PG&E Letter DCL-17-009

Docket No. 50-275, OL-DPR-80
Docket No. 50-323, OL-DPR-82
Diablo Canyon Power Plant Units 1 and 2
Appeal of Final Significance Determination Process Finding; EA-16-168

Summary of Basis for Appeal of Final Significance Determination

Final Significance Determination Appeal **Cornerstone: Mitigating Systems**

Figure 1 – Event Timeline

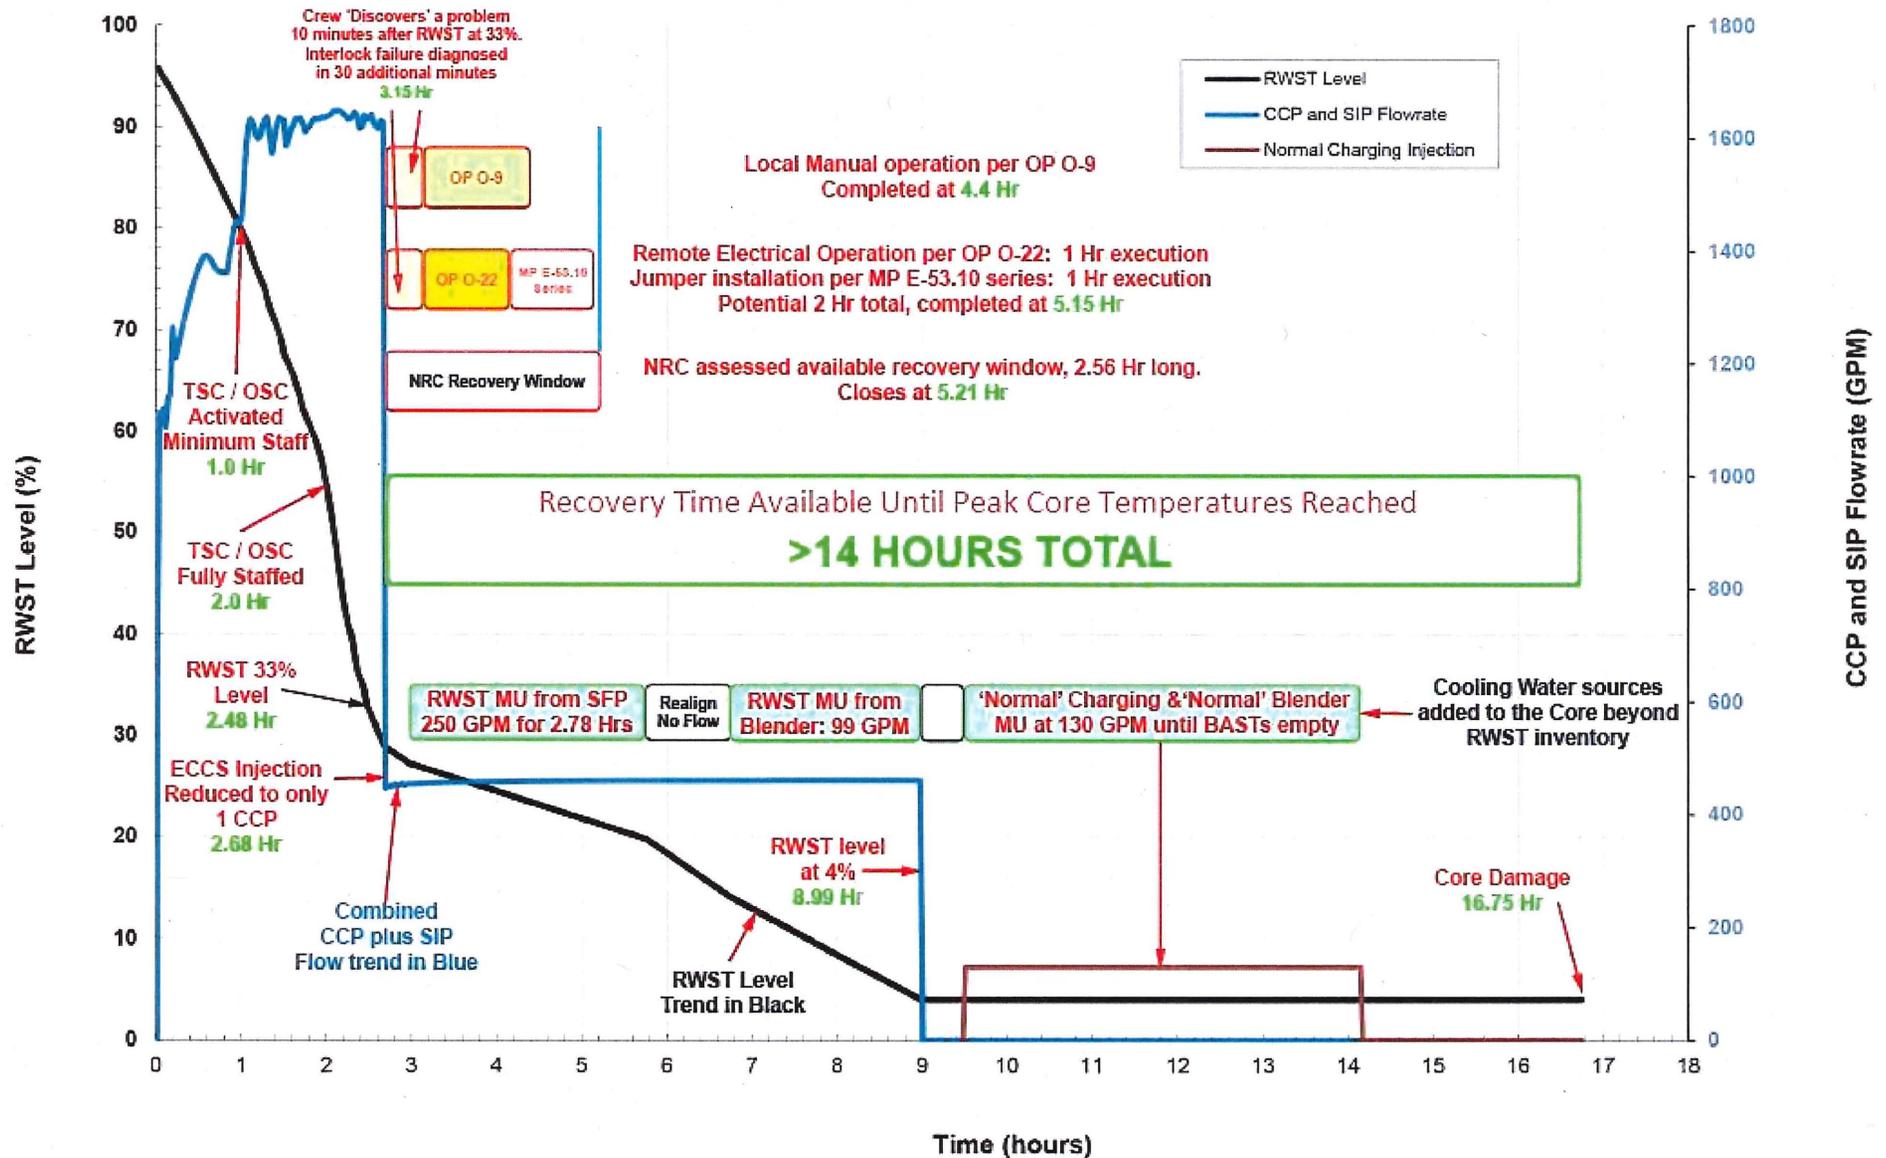
- Control Room-directed EOP actions that extend the time available for recovery of Valve SI-2-8982B and TSC-directed local recovery actions proceed in parallel (not sequentially).
- Two TSC-directed local recovery actions (electrical and mechanical recovery) proceed in parallel (not sequentially)³ using separate response teams.
- Consideration of Control Room-directed actions in parallel with TSC-directed local recovery actions results in approximately 14 hours available for recovery of Valve SI-2-8982B.

PG&E modeled 30 minutes of no makeup to the RCS while operators perform the alignments directed by EOP ECA-1.1, Appendix W. At 7.01 hours after reaching 33 percent level, makeup to the RCS from the VCT, as supplied by the blender, is initiated at the maximum makeup flow of 130 gallons per minute (gpm). This makeup rate is not sufficient to match the decay heat load required flow for continued cooling, but does significantly extend the time until core damage. The procedurally required action to implement EOP ECA-1.1, Appendix W, following RWST level reaching 4 percent significantly extends the time available for recovery actions.
